Access Compliance Report

Public Rights-of-Way

(Curb Ramps)

Intersection ID: 43075	Main Street: SCOTT_AV	Cross Street: ROMANY_RD	Location: W
ADA ID: 61343FF57A81	Ramp Type: Perp	Initial Pass/Fail: Fail	Overall Compliance: No
			Severity Score: 21.25

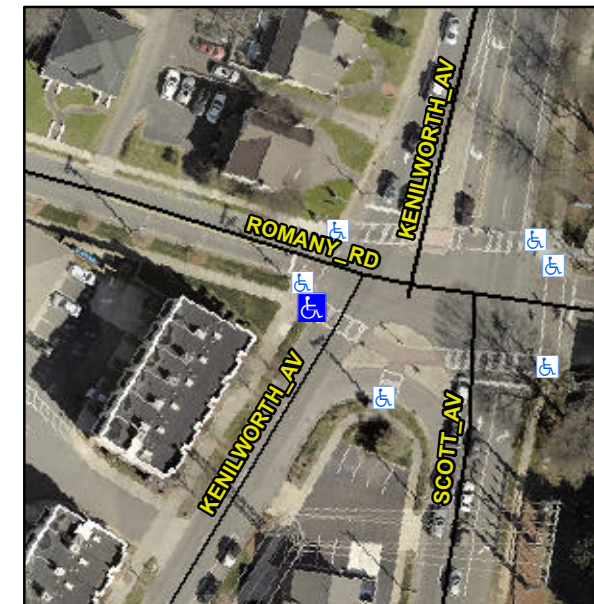
R304.5.1, R304.2.2

Compliance	Description	Data	Compliance	Description	Data
N/A	Ramp Length (in)	89.0	No	Ramp Slope (%)	8.9
No	Ramp Width (in)	47.5	Yes	Ramp XSlope (%)	0.5
N/A	Flare Type LT	N/A	N/A	Flare Type RT	N/A
N/A	Flare Slope LT (%)	N/A	N/A	Flare Slope RT (%)	N/A
N/A	Flare Traversable LT?	N/A	N/A	Flare Traversable RT?	N/A
N/A	Landing Length (in)	N/A	N/A	DWS Provided?	N/A
N/A	Landing Width (in)	N/A	N/A	DWS Contrast?	N/A
N/A	Landing Slope (%)	N/A	N/A	DWS Length (in)	N/A
N/A	Landing X Slope (%)	N/A	N/A	DWS Full Width?	N/A
N/A	Landing Curb? (Y/N)	N/A	N/A	DWS Offset (in)	N/A
N/A	Shared Landing?	N/A			
N/A	Gutter Ponding?	N/A	N/A	Gutter Slope (%)	N/A
N/A	Gutter Lip Ht (in)	N/A	N/A	Gutter X Slope (%)	N/A
N/A	Painted X Walk1?	Yes	N/A	Painted X Walk2?	N/A
	X Walk 1 Direction	To SE		X Walk 2 Direction	N/A
N/A	X Walk 1 Width (in)	111.0	N/A	X Walk 2 Width (in)	N/A
	X Walk 1 Slope (%)	4.4		X Walk 2 Slope (%)	N/A
	X Walk 1 X Slope (%)	1.3		X Walk 2 X Slope (%)	N/A

Remove & Replace Entire Ramp.
